Code Modification or Alternate Request

MEMORANDUM

TO: Seattle Department of Construction & Inspections
FROM: Mathew Lipps
DISTRIBUTION: file
DATE: March 23, 2022
PROJECT: 6771347-CN: 101 W. Roy St.
SUBJECT: Code Alternate Request 713.13.4

Runberg Architecture Group is seeking a Code Alternate Request regarding the crossing of conduits and piping through a Waste Chute Termination Room.

System No. C-AJ-5185

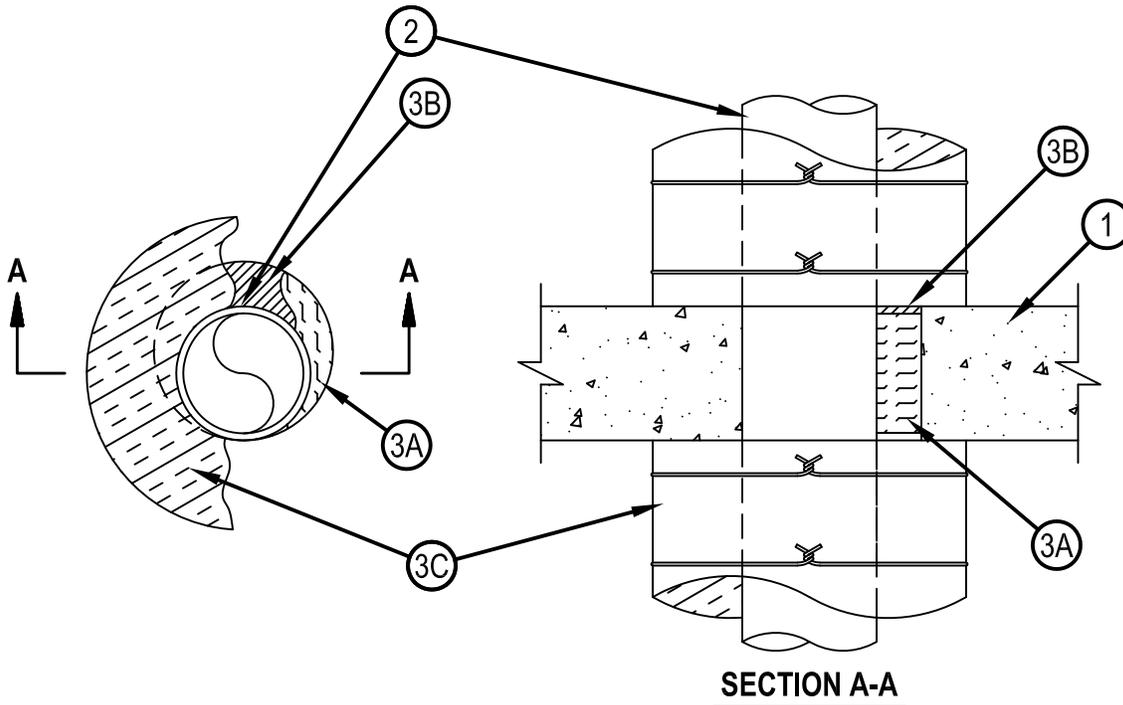
To maintain an equivalent level of lifesafety, penetrating items are appropriately fire-stopped per SBC Section 714, please see attached fire stopping systems (System No. C-AJ-5185 for ceiling and System No. W-L-1054 for walls.)

SDCI Comment: Rated penetrations to be verified by SDCI inspections. djw 04/13/2022
